**Joint Regional Planning Panel
(Sydney East Region)**

JRPP No.	2015SYE164
DA No.:	Demolition of all existing structures, construction of shop top housing development comprising 8 storeys to Green Street, 7 storeys to Maroubra Road with 2 retail tenancies fronting Maroubra Road and 1 fronting Green Street, 69 residential dwellings, 3 levels of basement car parking for 100 vehicles, landscaping and associated works.
Street Address	180-188 Maroubra Road, Maroubra (DA/813/2015)
Applicant	Darren John Beasley
Owner	Prime & Famous Pty. Ltd.
Number of Submissions	6
Recommendation	Refusal
Report By	Matthew Choi

Figure 5 – Elements of the proposed development shown protruding through the 25m height plane (shown red)

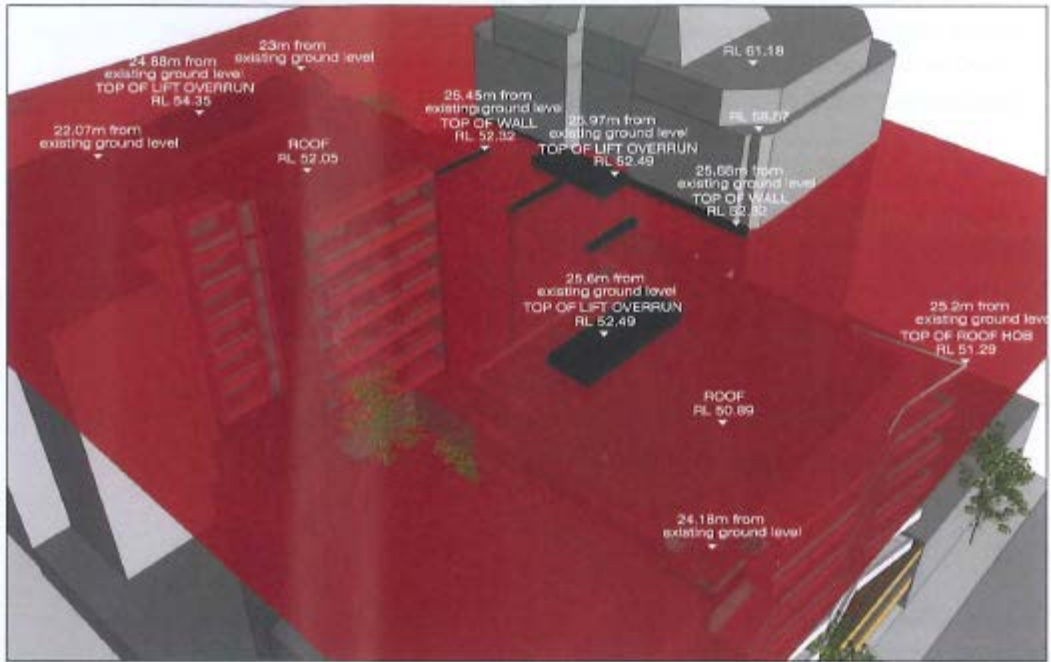
Planning comment:
<p>It is considered that the proposed variation from the maximum building height standard is not well founded in this instance for the following reasons:</p> <p>The RLEP 2012 applies maximum height standards to the Maroubra Junction Town centre. Pursuant to clause 4.3 of the RLEP, the height of the building on the subject site is not to exceed the maximum height shown for the land on the corresponding Heights of Buildings Map. The maximum building height standard for the subject site as stipulated in the RLEP 2012 is 25m.</p> <p>The RLEP 2012 height standard for the subject site is to be read in conjunction with the Randwick Comprehensive DCP 2013 (Part D4 – Maroubra Junction Centre), which allows for a two block envelope with a maximum height of 6 storeys along Maroubra Rd and 5 storeys along Green Street corresponding with a maximum height control of 21m and 18m respectively.</p>

The proposal will exceed the RDCP 2013 height control by 1 storey on Maroubra Rd and 3 storeys on Green St. Council's planning policies clearly anticipate a predominant building height of 5 to 6 storeys, hence any parts of the building that significantly breach both the height standard and storey control have the potential to compromise the strategic planning objectives for the Town Centre. The numerical standards contained in RLEP 2012 are the result of considerable community consultation and detailed analysis of the existing and emerging development patterns in the Randwick LGA. Strategic considerations in relation to density and height within the precinct were examined as part of the preparation of RLEP 2012 and RDCP 2013. The resultant LEP standards and DCP built form controls act as the key determinants in achieving a certain urban character and density. Allowing *ad hoc* increases in the density and scale of development on a project by project basis would undermine Council's planning framework and cumulatively impact to transform the character of the Town Centre. On this basis, it is considered that the upholding of the height standard is necessary in this particular case and is in the public interest. The applicant has failed to recognise the role of both the RLEP 2012 maximum height standard and maximum storey control in the RDCP 2013 in providing for the orderly development of land. It should also be noted that the 25m height limit has been designed so that buildings within the Maroubra Junction Town Centre can comfortably fit within the height standard which should not be used as means by which to introduce additional storeys that would be inconsistent with the existing pattern of development and beyond that anticipated by the built form controls for the Town Centre.

In this instance, the additional height results in a building that will have a size and scale that is inconsistent with the desired future character of the town centre. The combined effect of the maximum height and storey controls would provide for a building that is manifestly smaller than that proposed. It is acknowledged that the applicant has attempted to redistribute some of the building volume away from the side boundaries of the tower building at 172-178 Maroubra Rd, but these benefits are largely diminished by the increase in height through the proposed additional storeys.

Figure 6 - Comparison of impact on western neighbour

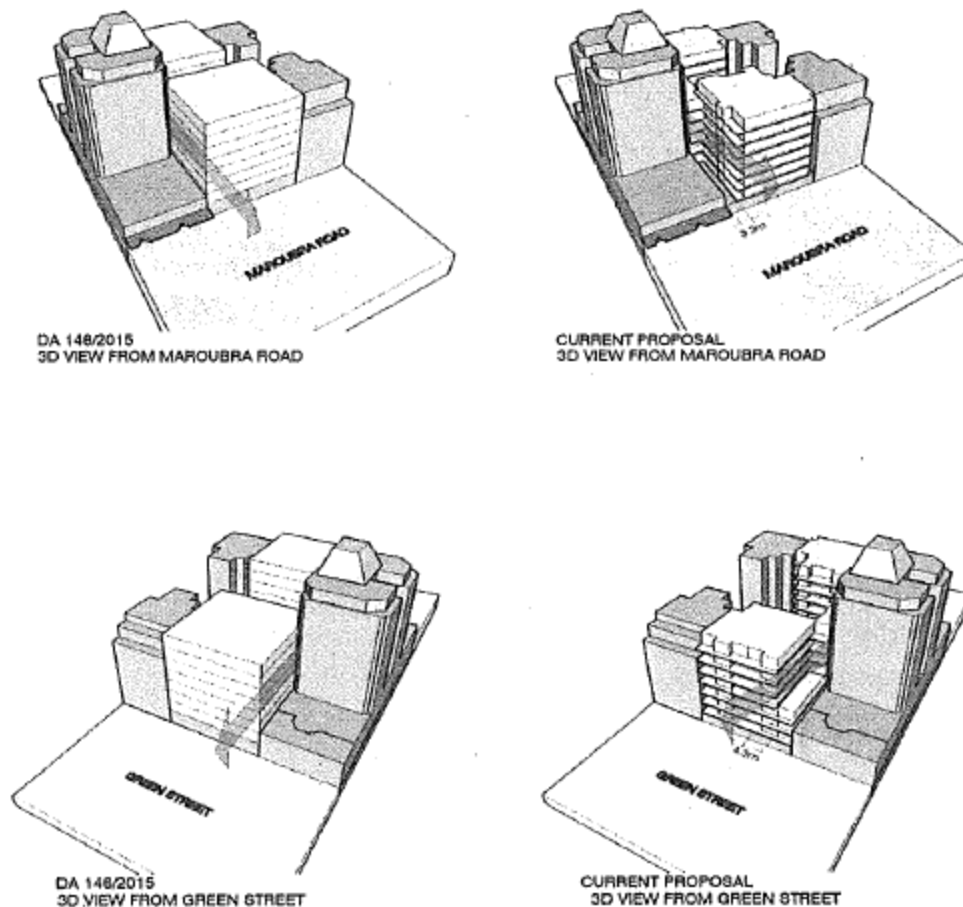
The proposal has not been designed to achieve the planning objectives for the locality and does not accord with the desired future scale and character of development whilst minimising potential adverse impacts on surrounding properties.

The applicant's written request has not successfully demonstrated that there are sufficient environmental planning grounds to justify contravening the development standard.
